## **E.SYBOX VERSION SW 4.12**

Improvements introduced with the firmware  
version SW 4.12

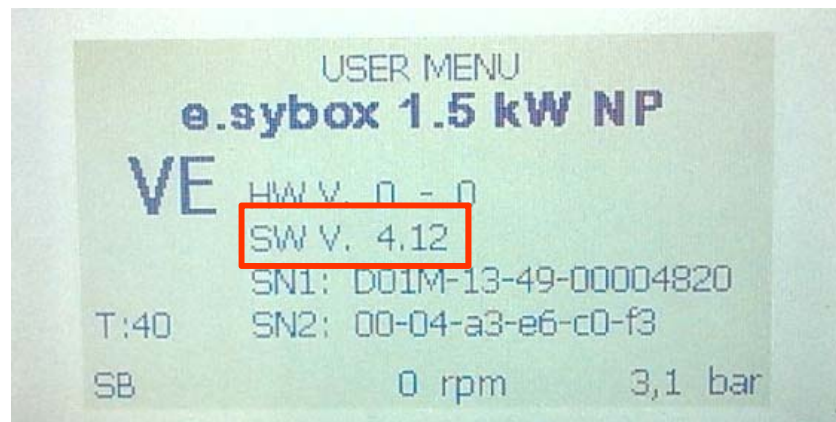
## 4) Solved false alarms E18-19 and E20-21:

Revised the intervention thresholds of certain protections that create false errors.

Added Pop up displaying the type of error (E18-19, locked rotor or E20-21, dry running), the message "Please wait while letting powered" and the countdown for recovery.
